c/o London Luton Airport Operations Ltd.
Navigation House, Airport Way, Luton
Bedfordshire. LU2 9LY

RESPONSE TO NATS TC NORTH CONSULTATION

17 June 2008

Figure F56: Proposed Leq (16 hrs) Contours for Luton (estimated for 2009 and 2014 traffic levels)

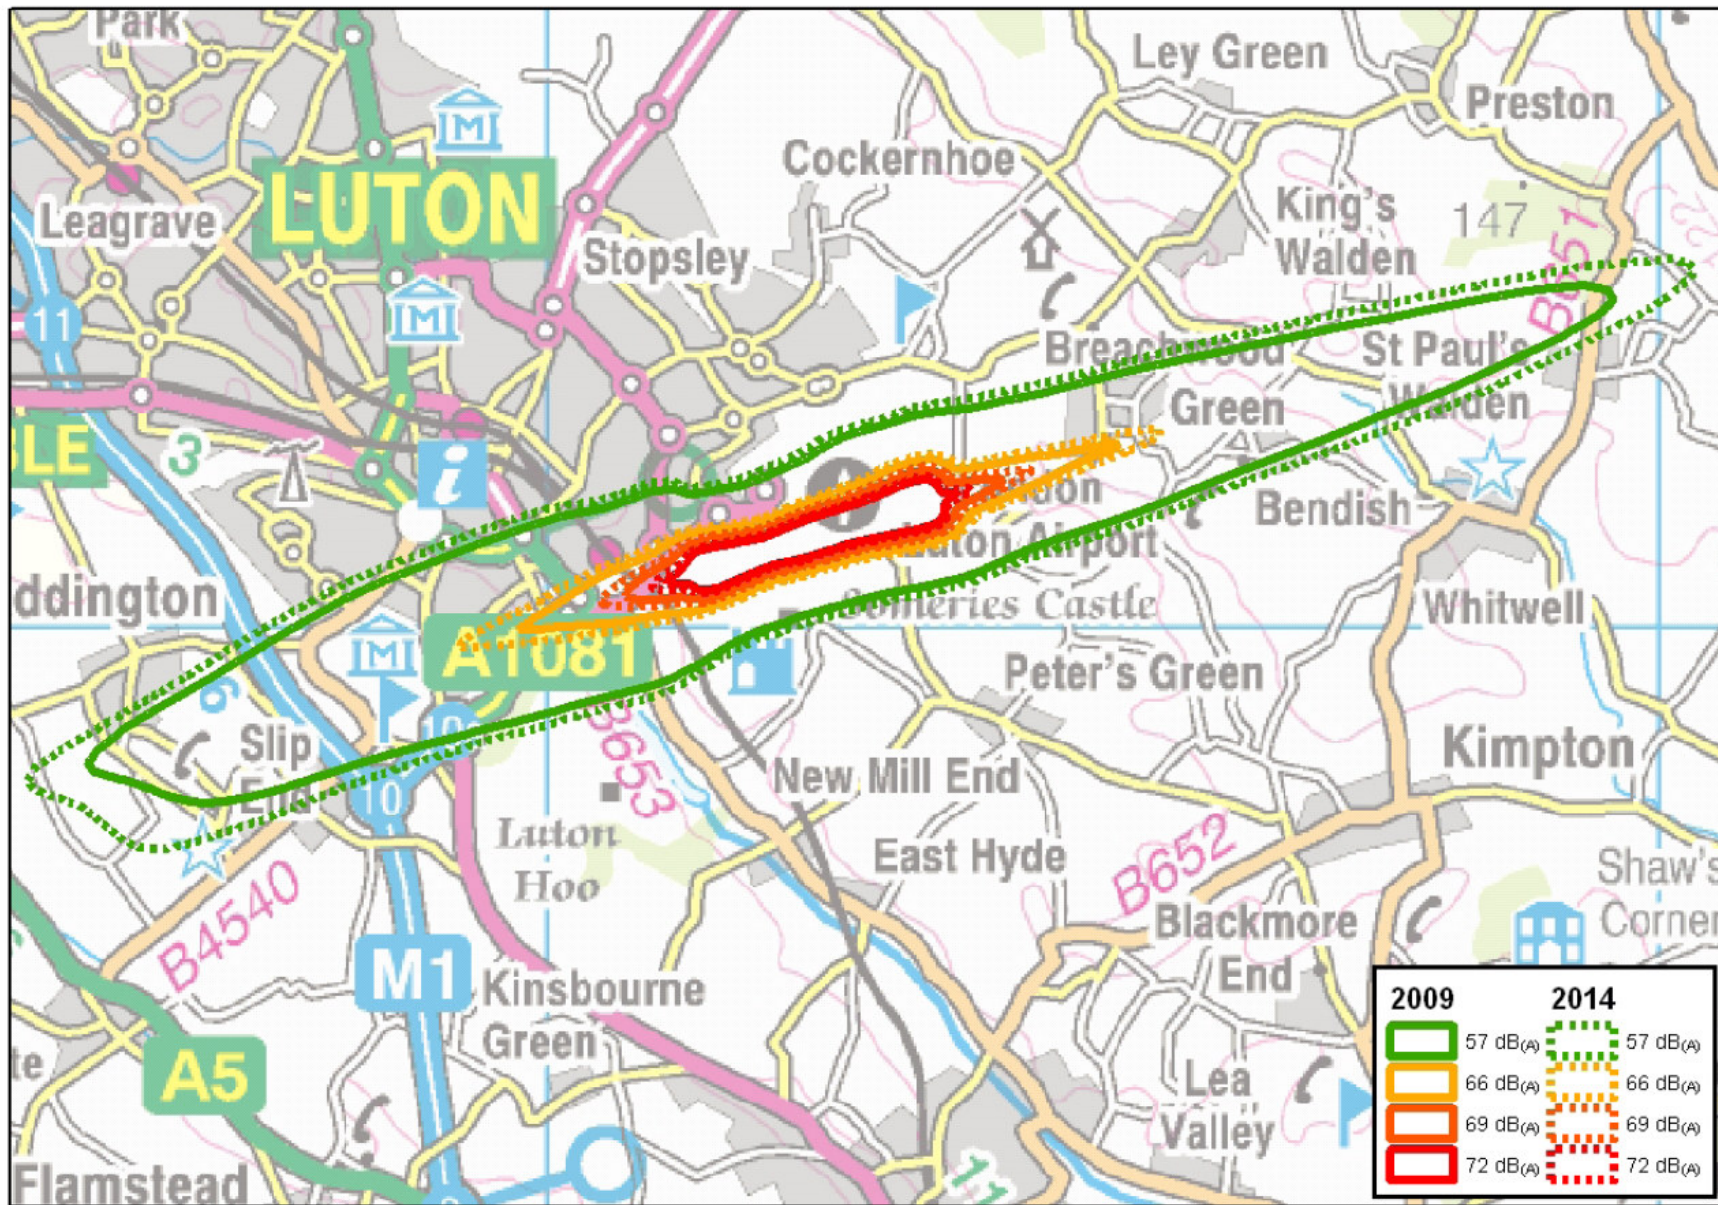
2.1 The effects on London Luton Airport operations impacts are very significant. This can be illustrated by the forecast 2009 daytime noise contours, viz

No population data was provided for the Luton 2014 noise contours given in the Consultation papers. Those would have related to conditions with the Airspace used as proposed by NATS. The population within the 2014 Luton contours will be greater or equal to that of the old 1984 contour currently used as the not to be exceeded planning condition noise limit at Luton. (Appendix B contains a copy of the NATS 2014 noise contour).

The effects indicate over 5000 people to be newly exposed to noise at 57 dB L_{Aeq,16h}. This is the level used by Central Government based on 1980's research as the level of daytime noise marking the approximate onset of significant community annoyance. NATS has not provided any night-time contours, but have provided some SEL footprints.

Figure 6. Modelled SEL footprints Airbus A300 (Noisiest aircraft type) Easterly Departures to the East Luton Runway 08

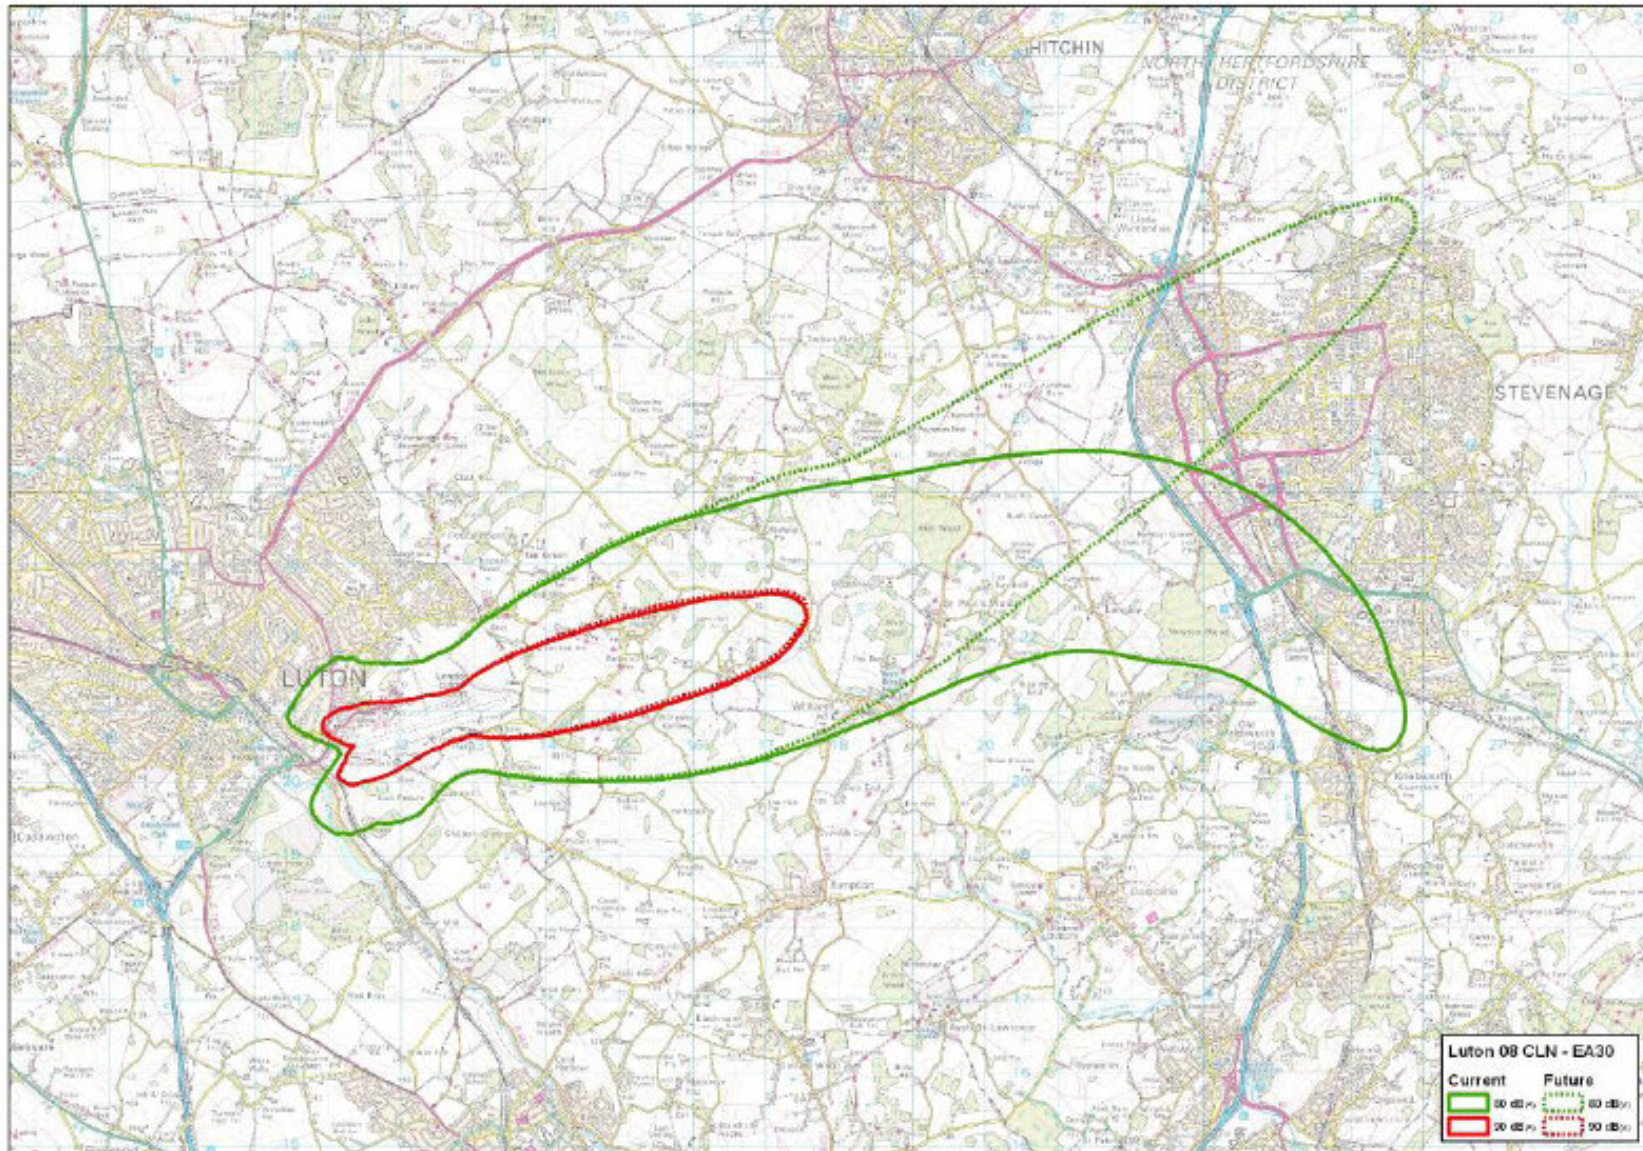
2.2 The considerable change in routes is illustrated by the aircraft noise footprints given in the NATS separate SEL technical report, e.g. for departures to the east – see Figure 6.
for departures to the west – see Figure 12
(Appendix B contains copies of these figures)

Figure 12 Modelled SEL Footprints Westerly Departures to the South West Airbus 300 (Noisiest aircraft type)

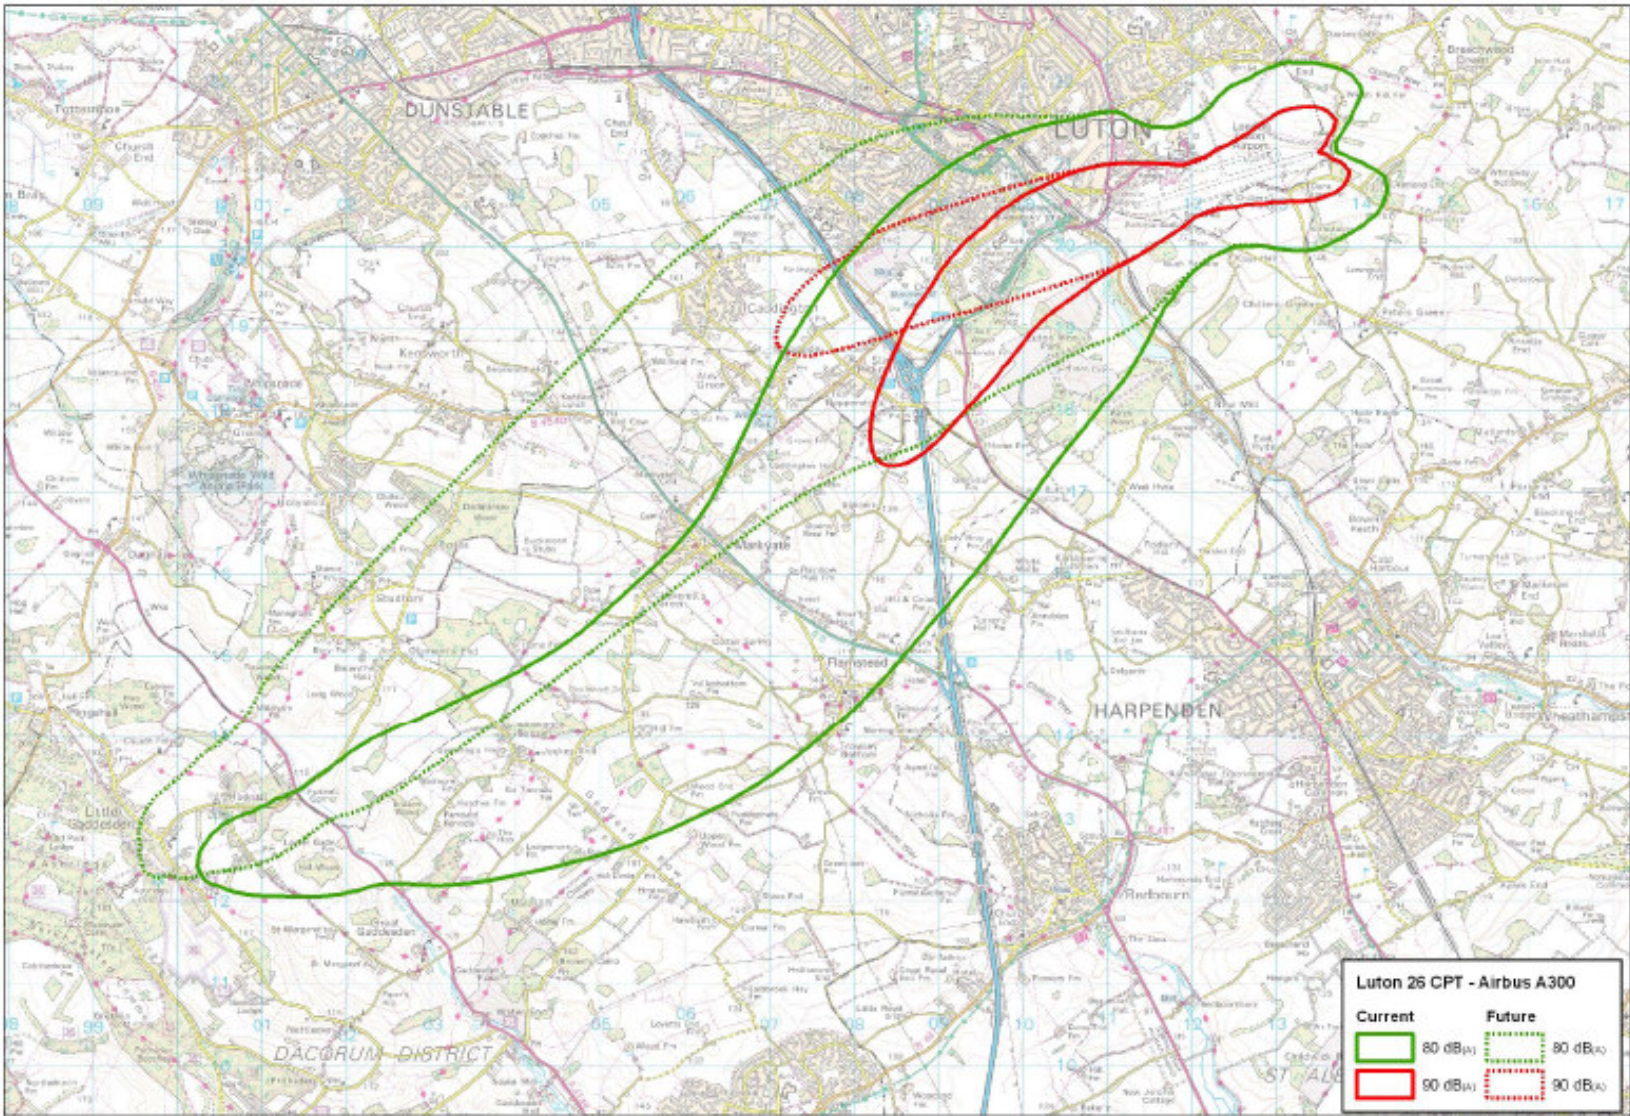
No population data was provided for these aircraft noise footprints. The greatest effect is the alteration shown in Figure 12, which shows that noise levels greater than 90 dB(A) SEL will be incident on many properties in South Luton. This level is that

used by Government in assessing the impact of aircraft noise on sleep disturbance, and by some UK airports as the threshold of eligibility for soundproofing to mitigate effects of night noise.
